**Service Bulletin:** SB EC135-8010; Eurocopter EC135 Air Conditioner Aft Evaporator Wiring Harness Blower Motor Connector Upgrade.

**Subject:** Aft Evaporator Wiring Harness Blower Motor Connector Upgrade.

**Date:** 25, November 2009

**Applicability:** Eurocopter Helicopter model EC135 Equipped with the Air Comm Corporation EC135-200 & EC135-202 Air Conditioning System for kit serial numbers EC135-002 thru EC135-092. Kit serial number EC135-093 and subsequent do not require application of this service bulletin.

(Figure 1-1 View looking up at the aft evaporator blower & wire harness)

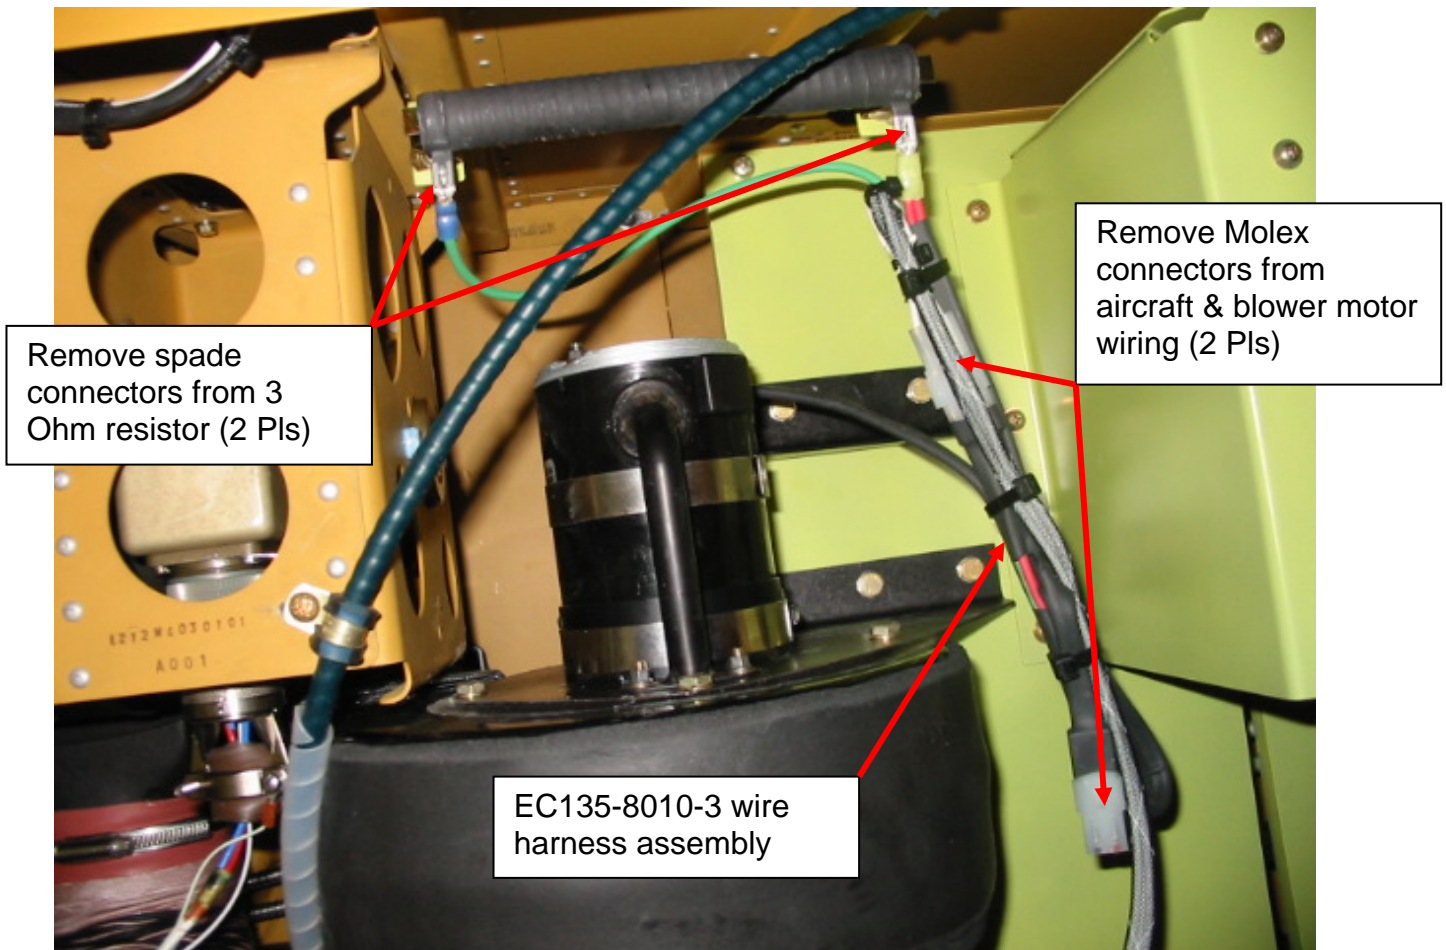
1. Access the aft evaporator blower assembly & wire harness, located in the avionics bay in the aircraft belly, just aft of the forward cross tube.
2. Disconnect the spade connector ends of the EC135-8010-3 wire harness from the 3 Ohm/100 Watt resistor located on the aft bulk head in this compartment. (figure 1-1)
3. Disconnect the Molex connector ends of the EC135-8010-3 wire harness from the aft evaporator blower motor & aircraft wiring connections, and discard the -3 wire harness assembly. (figure 1-1)

4. Remove and discard the Molex connector plug (P/N 03-09-1032) & sockets (P/N 02-09-1104) from the aircraft wiring. (figure 1-1)
5. Remove and discard the Molex receptacle (P/N 03-09-2022) & pins (P/N 02-09-2103) from the aft blower motor wiring (figure 1-1)

(Figure 1-2 Electrical Schematic)

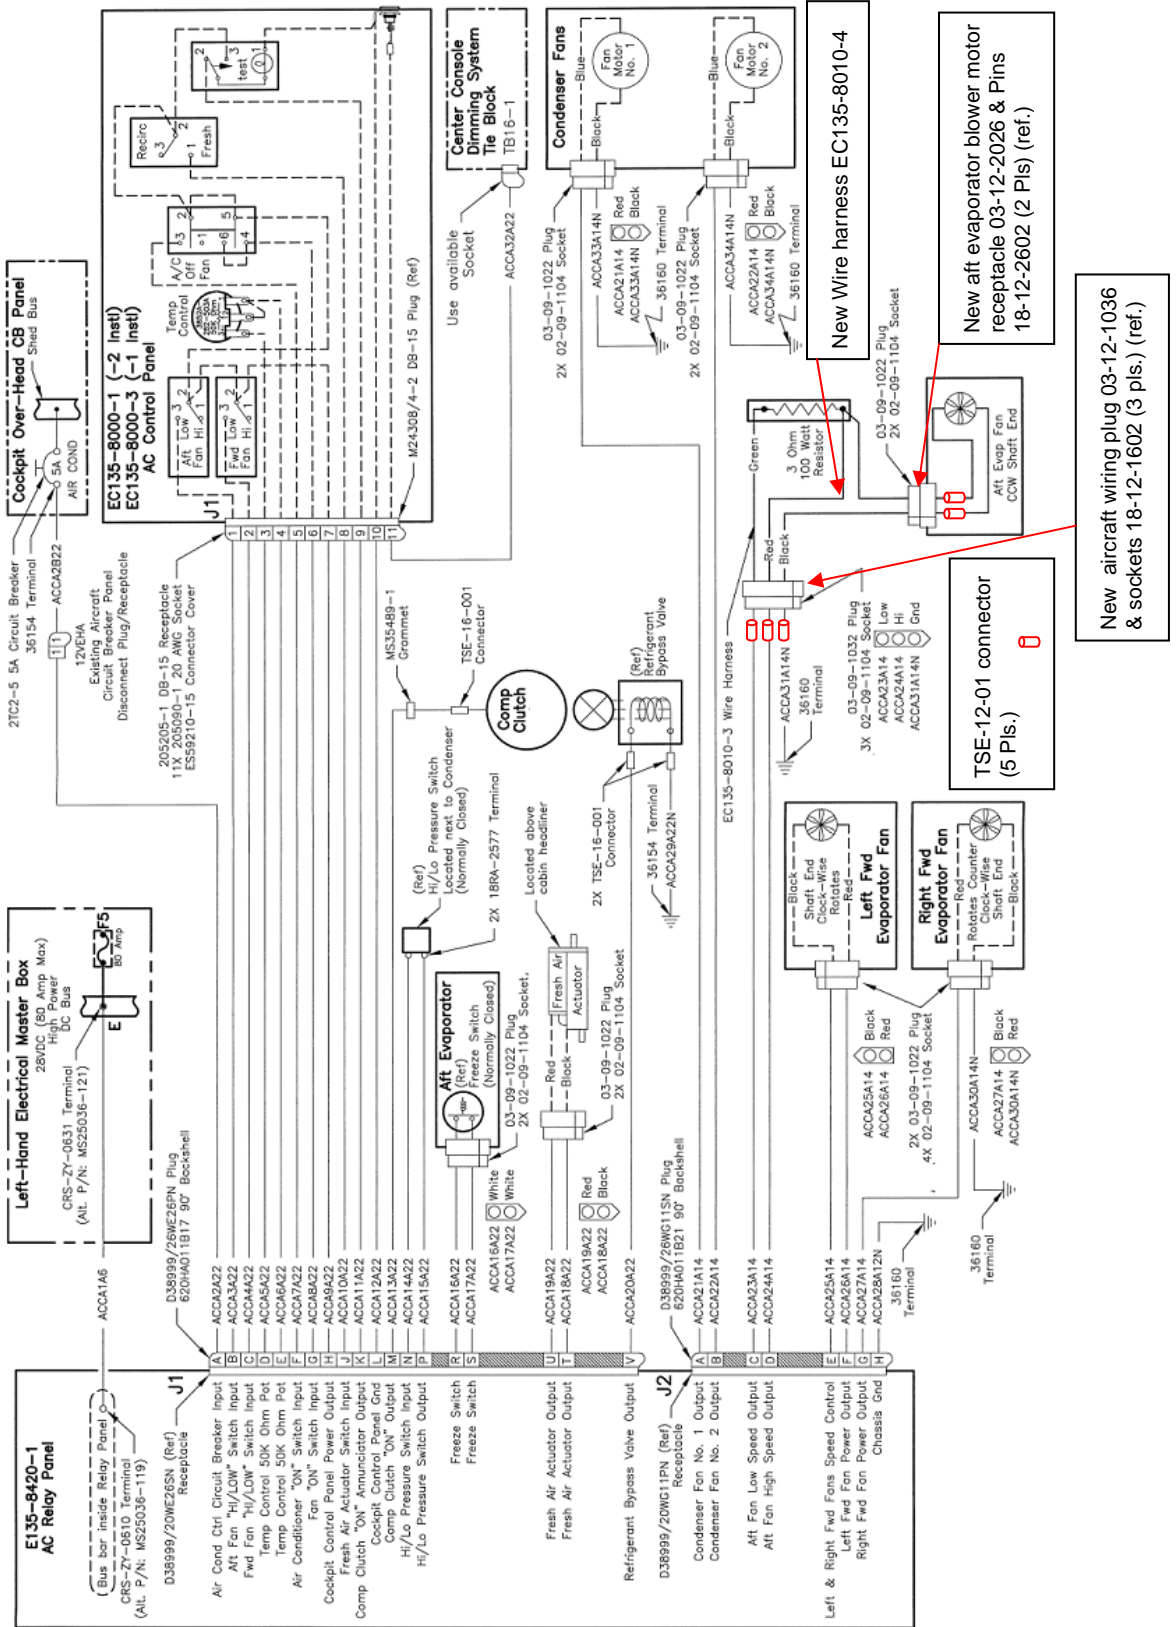
1. Install EC135-8010-4 Wire harness to existing 3 Ohm/100 watt resistor as shown in (figure 1-2).
2. Install TSE-12-01 Connectors to wires ACCA23A14, ACCA24A14, ACCA31A14N, and both of the leads to the aft evaporator blower motor. (figure 1-2)
